Statement of Response to the Opinion of An Bord Pleanála

**PROPOSED STRATEGIC HOUSING
DEVELOPMENT, MONACNAPA,
BLARNEY, CORK**

Client	Eoin Sheehan
Project Title	Proposed Strategic Housing Development, Monacnapa, Blarney, Cork
Job No.	CON17113
Document Title	Response to the Opinion of An Bord Pleanála
Number of Pages	22 (excluding appendices)

Plate 8: Proposed development site relative to the existing pedestrian connections to Blarney Town Centre

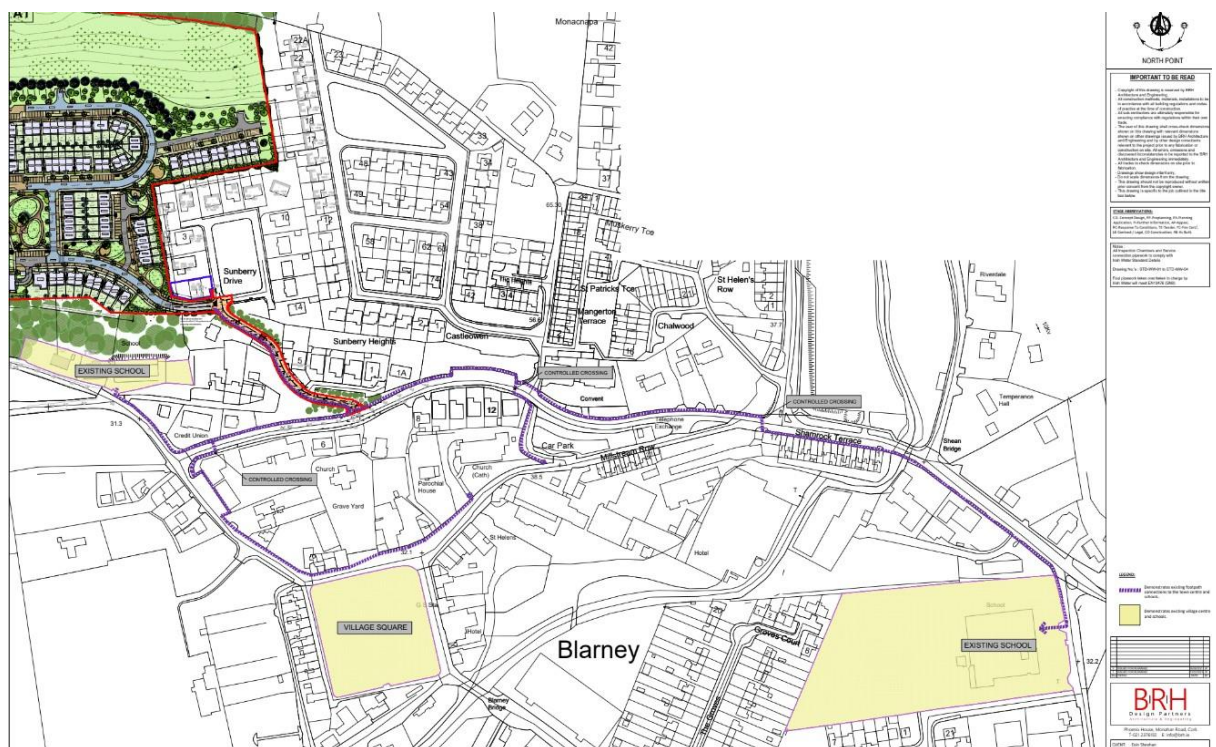
3. A layout plan and report that address and provides details of pedestrian connectivity to Blarney Town Centre.
4. A site layout plan indicating what areas, if any, are to be taken in charge by the planning authority, and the phased delivery of such public open spaces.

2.2.6 A Layout Plan, drawing no. 21_001_P03A, prepared by BRH Design Partners illustrates the existing pedestrian connectivity to Blarney Town Centre. An excerpt of this is illustrated in Plate 8 below:
